Serial No. 09/917,722

Docket No. P-0247

Reply to Office Action mailed December 28, 2004

AMENDMENTS TO THE DRAWINGS:

FIG. 1
BACKGROUND ART
PRIOR ART

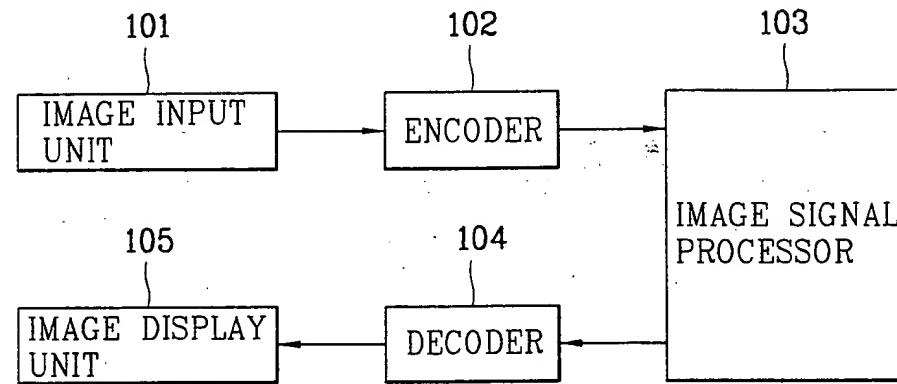
The Office Action states Figure 1 should be labeled as --Prior Art--. However, there is no indication of why Figure 1 is "prior art." That is, Figure 1 is properly labeled as --Background Art--. Applicants respectfully disagree with the Office Action's requirement. However, applicants have amended Figure 1 as suggested in the Office Action so as to further prosecution. This is not an admission as to Figure 1 being prior art.

The attached annotated sheets show changes to Figs. 1, 3 and 4. For example, Fig. 1 is amended to change “Background Art” to --Prior Art--. In Fig. 3, the outputs of block S12 have been reversed and in Fig. 4, the outputs of block S21 have been reversed. These changes are based on the specific discussion set forth in the specification.
